We sincerely thank Dr. Praplan for the careful review and encouraging comments. Our detailed responses are provided below, with the *reviewer's comments* and *our replies* distinguished by formatting. The line numbers referenced in our responses correspond to those in the revised manuscript.

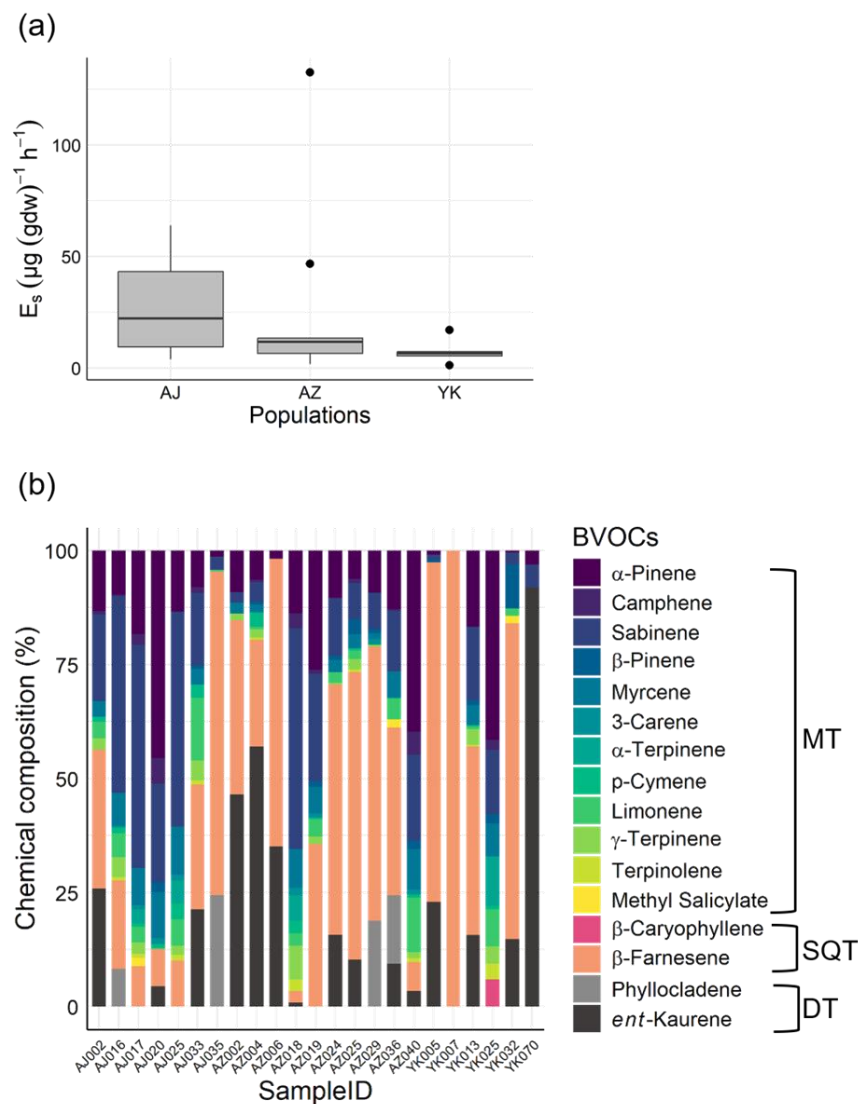
Comment3:- Figure 4: I am not sure to understand the boxplot (panel (a)) as there are datapoints scattered horizontally (why?) and some blue dots are on the same levels as gray crosses. It is not clear from the caption if the crosses are outliers, but if they are, why are there blue dots (not outliers?) at the same height? In panel (b), the three colors used for MTs are very similar and make it difficult to see what compounds are present in the emissions from the figure.

Response3: We agree that the presentation was confusing, and we have revised both panels accordingly.

For Figure 4 (a): Our original figure superimposed a jittered scatter plot onto the boxplot, which caused the confusing horizontal distribution and resulted in outliers appearing twice (once as a boxplot outlier, once as a scatter point). We acknowledge this was misleading. We have revised the figure to a standard boxplot format, showing only the outliers as individual points, which makes the plot much clearer. Additionally, we changed the y-axis units to $\mu\text{g (gdw)}^{-1} \text{ h}^{-1}$ to avoid the large numbers (e.g., 50,000) of the original ng-based scale and improve readability.

For Figure 4 (b): We also agree that the colors for the monoterpenes were too similar. We have addressed this by selecting a new, more distinct color palette in the revised figure to ensure each compound can be easily distinguished.

The revised version is provided below for reference.
